AMENDMENTS TO THE DRAWINGS

REMARKS

Drawings

Fig. 3

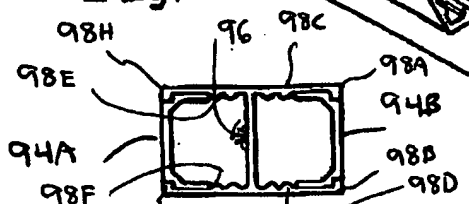
(4) The arrows at the ends of lead lines for reference numerals "26" and "34" in Fig. 3 have been deleted.

Fig. 14

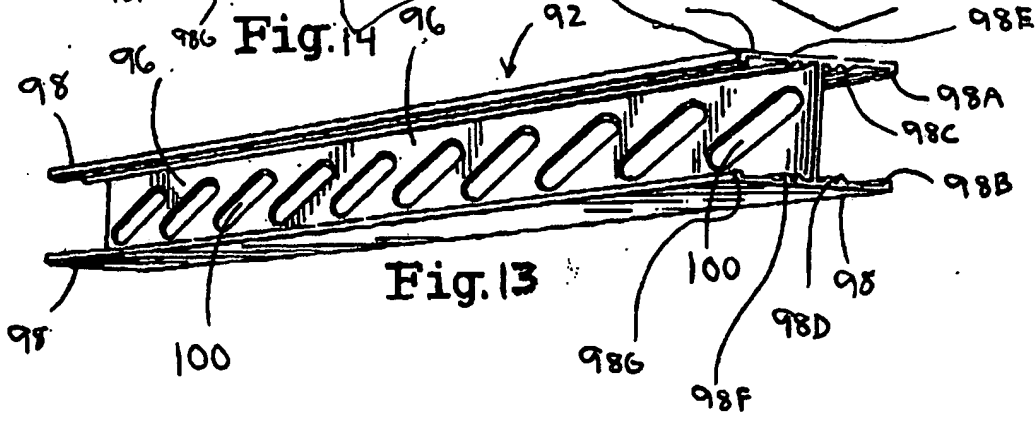
(12) The arrow at the end of the lead line for reference numeral "96" in Fig. 14 has been deleted.

Fig. 9

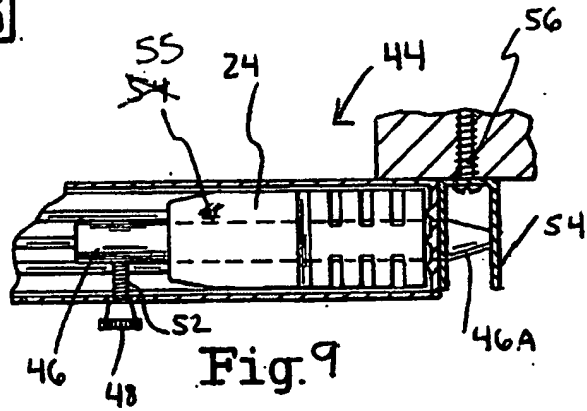
(9) The left-most occurrence of reference numeral "54" in Fig. 9 has been corrected to read "55", which is consistent with amended paragraph 0066 of the specification.

Regarding comment (1) at the first paragraph on page 8 of the Office Action, Applicants believe the Examiner is referring to Fig. 9 and not Fig. 6. As such, the left-most occurrence of reference numeral "54" in Fig. 9 has been corrected to read "55" to represent the "aperture through corner connector 24", which is consistent with amended paragraph 0066 of the specification. The right-most occurrence of reference numeral "54" correctly identifies the "latch pin receiver".

Fig. 4

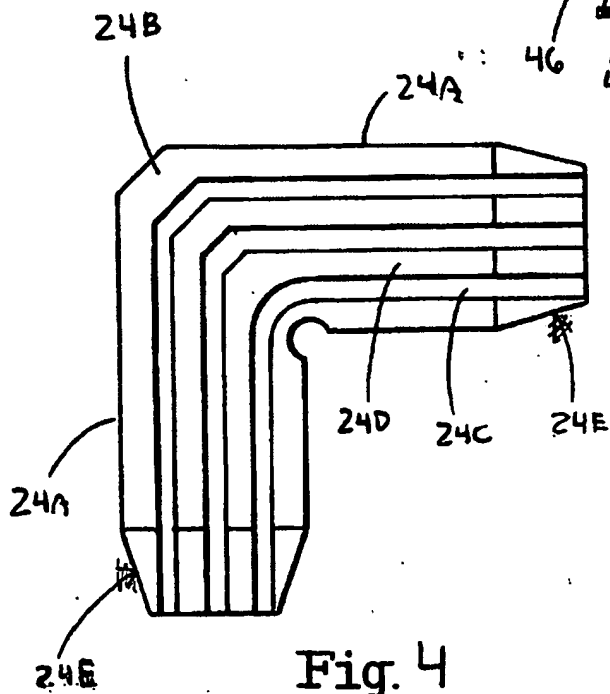
(5) The arrows at the ends of lead lines for both occurrences of reference numeral "24E" in Fig. 4 have been deleted.

Fig. 5

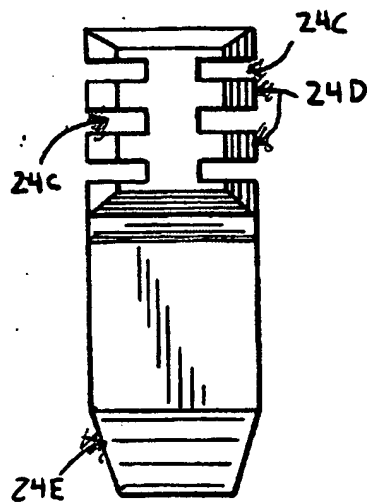
(6) The arrows at the ends of lead lines for reference numerals "24C", "24D" and "24E" in Fig. 5 have been deleted.

Fig. 15

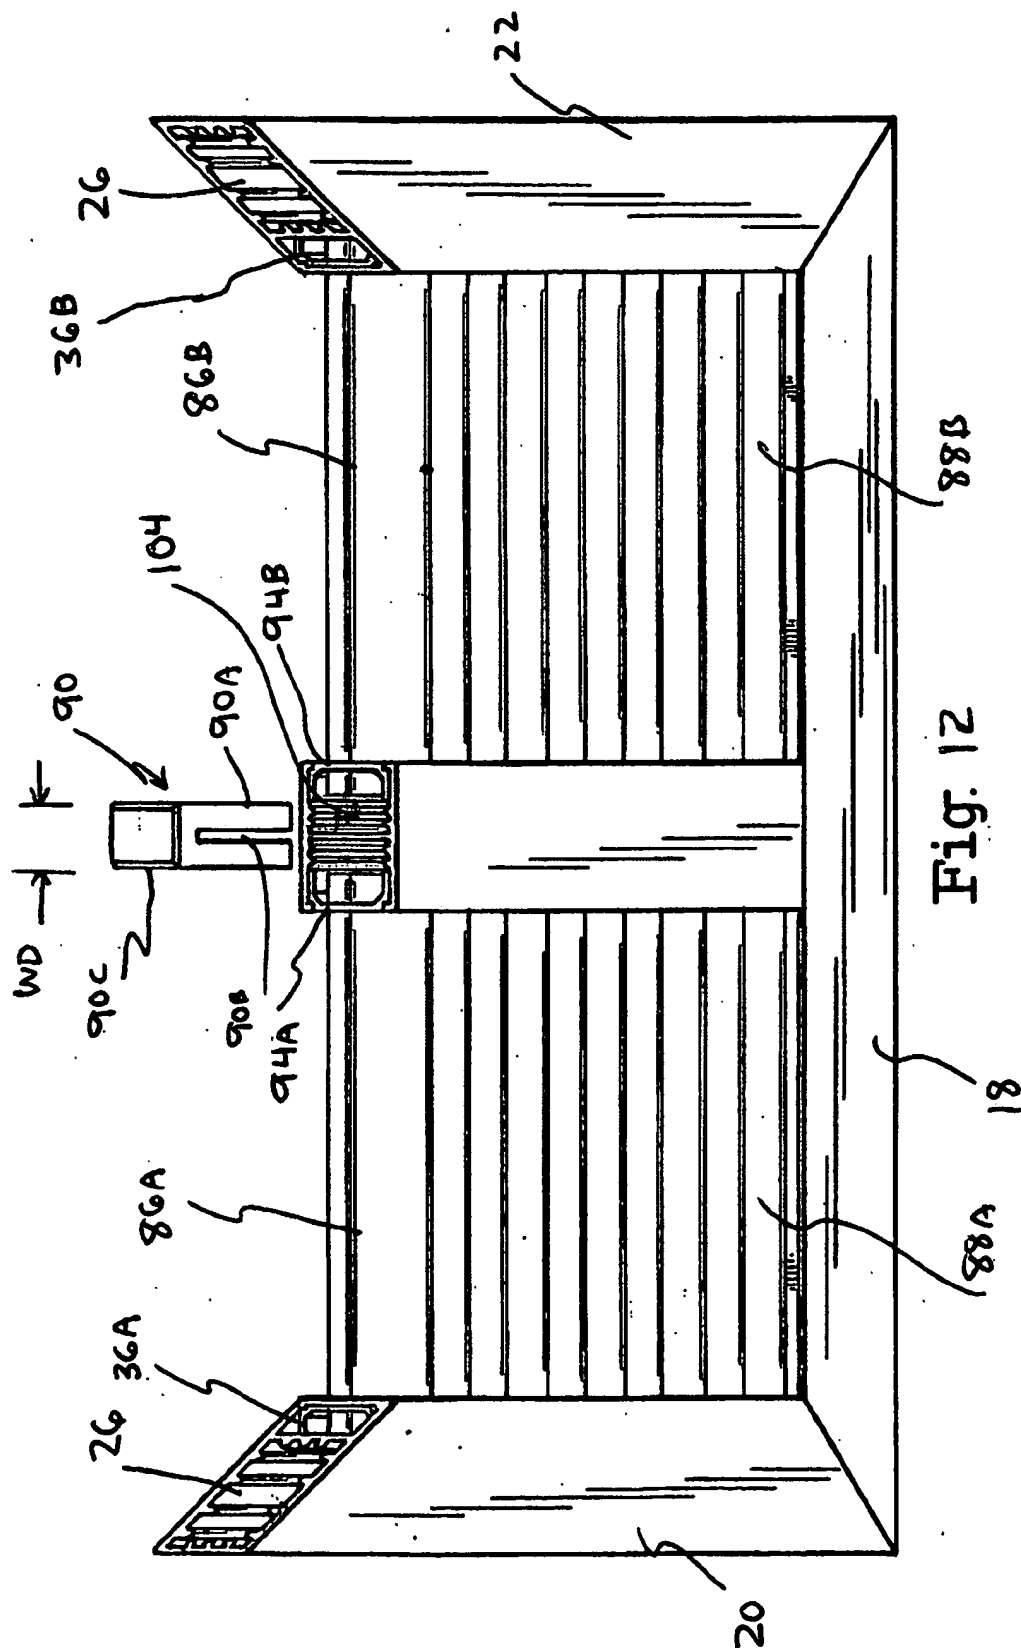
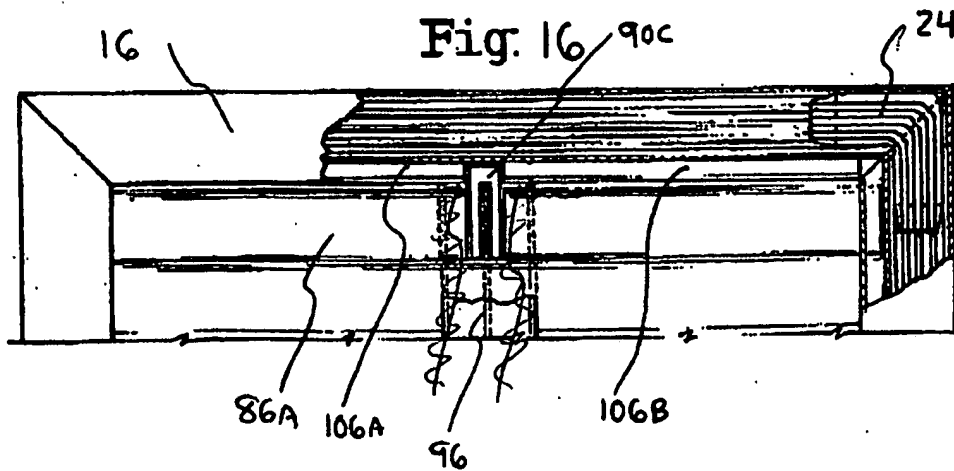
(13) The Fig. 15 appearing on the same sheet as Fig. 16 in the original drawings has been deleted, as it was a partial duplicate of the Fig. 15 with more reference numerals, which appeared on the last sheet of the original drawings. The Fig. 15 with more reference numerals, which appeared on the last sheet of the original drawings, has been kept and added to the sheet with Fig. 16, as suggested by the Examiner.

Fig. 16

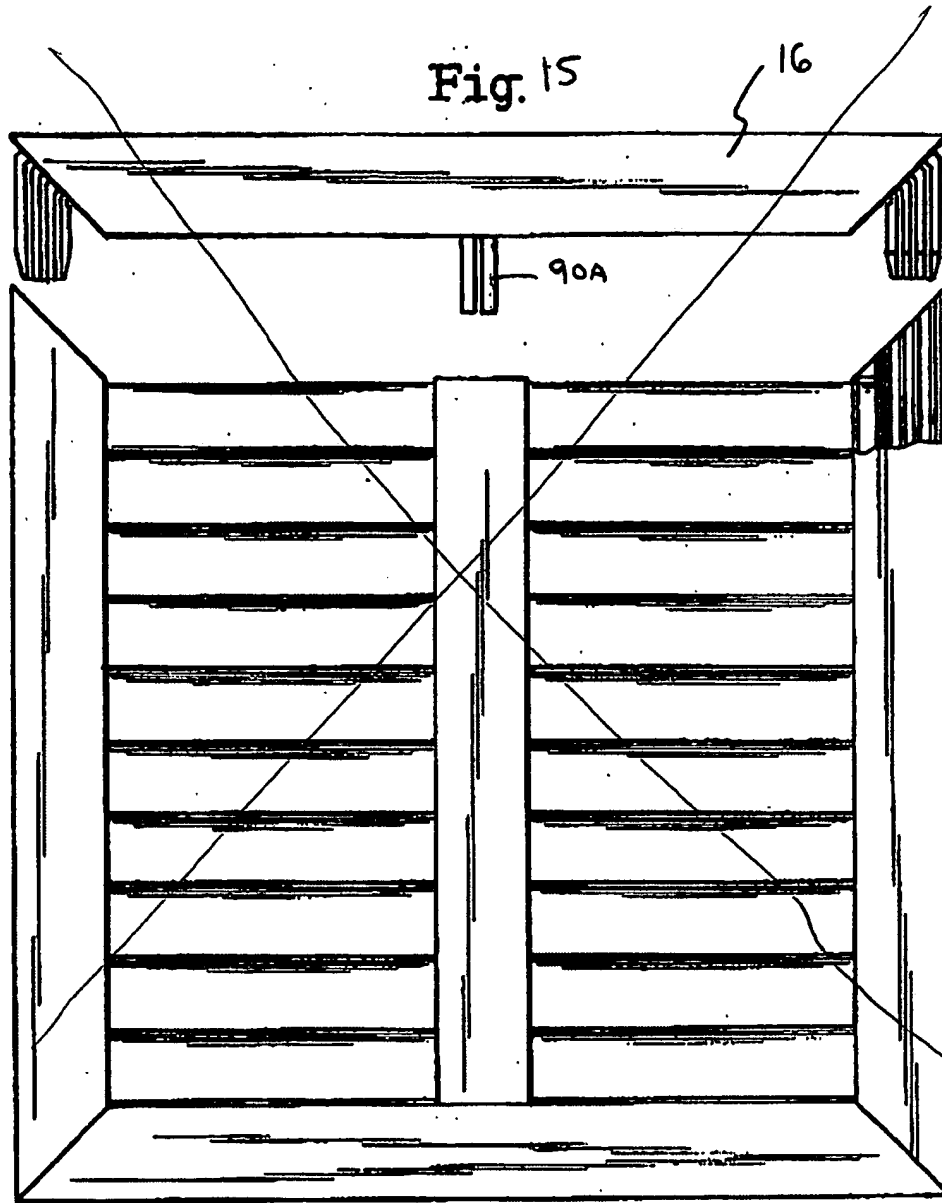
Additionally, the two extraneous lead lines surrounding reference numeral "96" in Fig. 16 have been removed.
